Technical Service Bulletin

Subject: REAR CONSOLE LID DOES NOT SLIDE SMOOTHLY	Bulletin No.: 09-016/22
	Last Issued : 04/29/2022

2020 CX-30

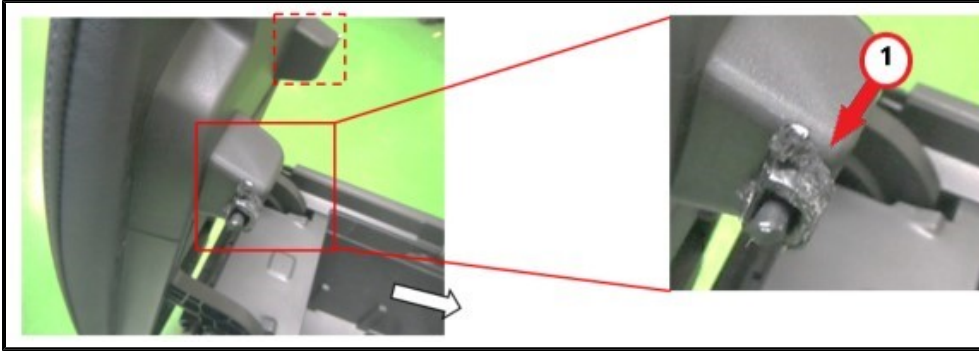
Some customers may complain that the rear console lid does not slide smoothly. This may be caused by improperly positioned felt pads attached to the rear console lid lock, which may have moved out of position after repetitive use. The exposed adhesive residue may stick to the rail and disrupt smooth sliding operation.

To eliminate this concern, the felt pad positions have been changed.

<p>A ↑ <Side view of lid lock></p>	<p>Attach Felt A (1) to lid lock</p>
---	--------------------------------------

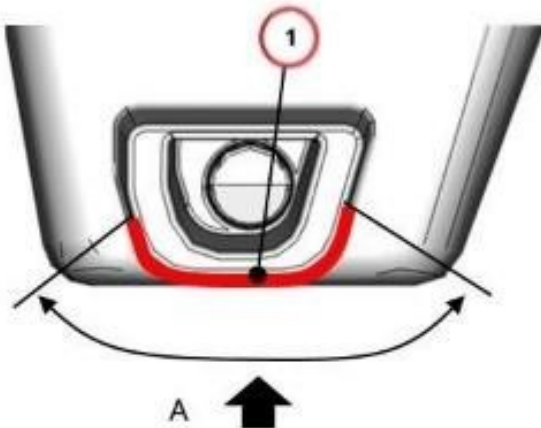
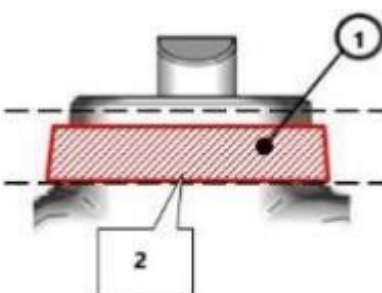
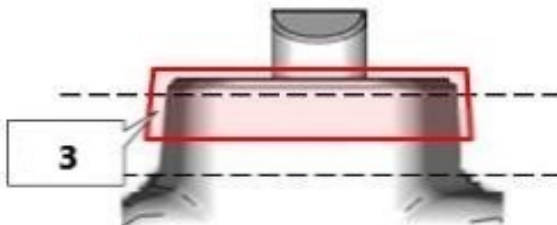
5. Prepare the felts as shown and Attach Felt A and Felt B as shown below.

<p>Felt A: 0.2 x 0.8 in (5 x 20mm) Cut Felt (1) to 0.4 x 0.8 inch (10 x 20mm) with thickness 0.2 inch (0.5mm) in half along the slit line on the felt to establish two pieces.</p>	<p>Felt B: 0.18 x 1.7 inch (4.5 x 43mm) Cut Felt (2) to 0.35 x 1.7 inch (9 x 43mm) with thickness 0.2 inch (0.5mm) in half along the slit line on the felt to establish two pieces.</p>
---	--

| 2. The felt edge must attach the lid along the entire length. | 3. The felt edge should not come out of the lid lock rim. |

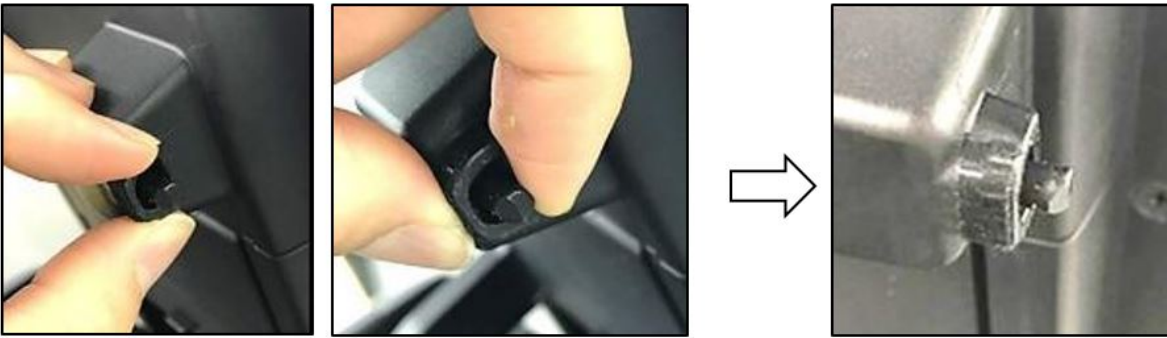
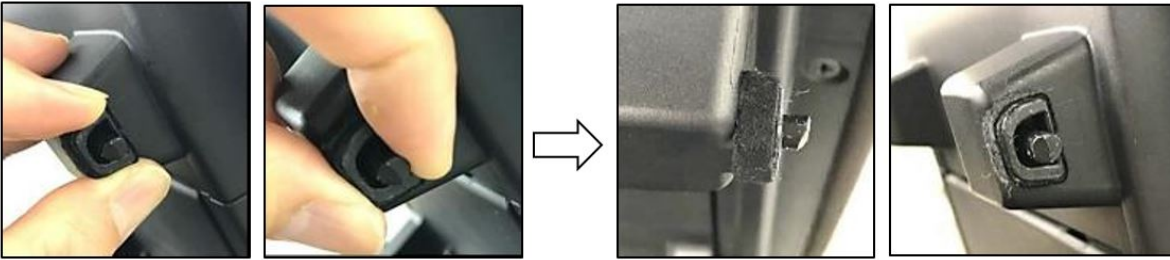
NOTE: Felt B must be attached so that its two ends are located on the lock's upper face, symmetrical to the upper face central line (1), as shown below. Also, the ends of Felt B must not touch each other.

8. Glue Felt B onto Felt A (2) as shown below.

<p><Side view of lid lock></p>	<p>3. Lock's upper face central line 4. Felt B 5. Felt A</p> <p>6. Felt B 7. Felt A</p>
<p>Felt B Installation - Good</p>	<p>Felt B Installation - No Good</p>
<p><View from B></p>	
<p>2 and 8: Glue in such a way that the Felt B border does not extend past the edge of Felt A.</p>
